Change of packaging – 2762070000 USB-MIC2.0B S1V 1N1 RL BK

the products of SNAP IN PCB terminals MTS 5 will be changed after a transitional period.
Please pass on this Product Change Notification (PCN) to your employees and, if applicable, to your customers.

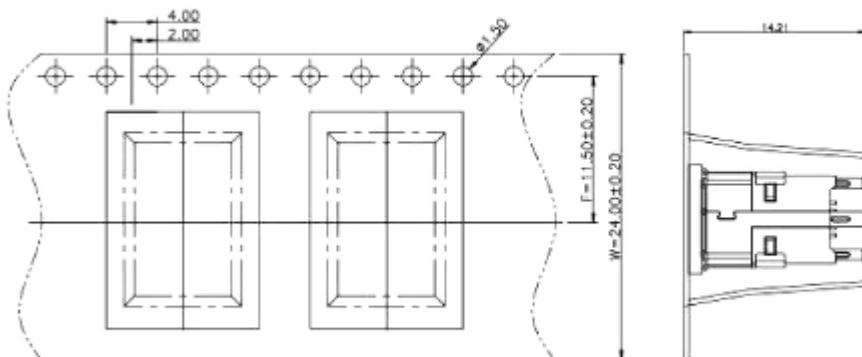
Old packaging	New packaging
<ul style="list-style-type: none">- Reel-diameter: 380mm- Pitch of tape pockets: 16mm	<ul style="list-style-type: none">- Reel-diameter: 330mm- Pitch of tape pockets: 12mm

The new orientation of the product in the tape and further detailed information can be found in the drawing below.

Old packaging (drawing)

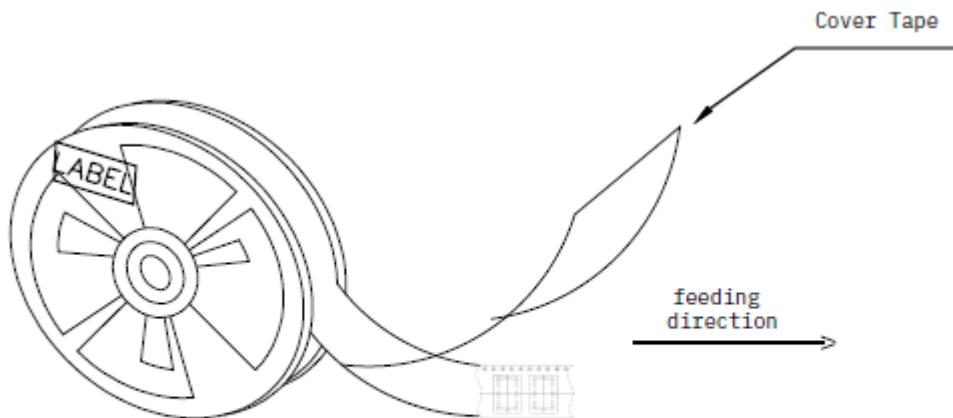
Reel
dia = 380 mm * 24.8 mm
400 pcs/ reel
Initial and end tape 5 cavities empty

Clear position of the
product in the reel

New packaging (drawing)

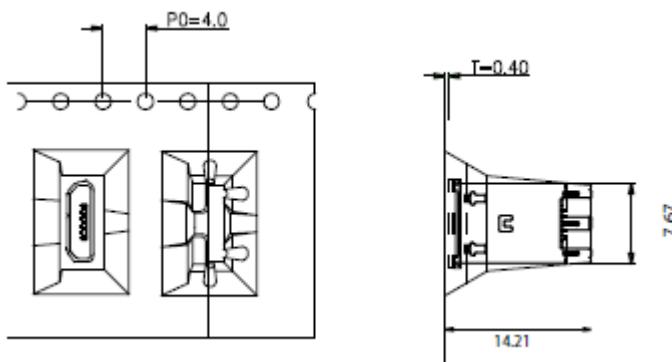
Reel
dia = 330 mm * 24.8 mm

400 pcs/ reel
Initial and end tape 5 cavities empty

Tape Reel: W = 24 mm, P = 12 mm
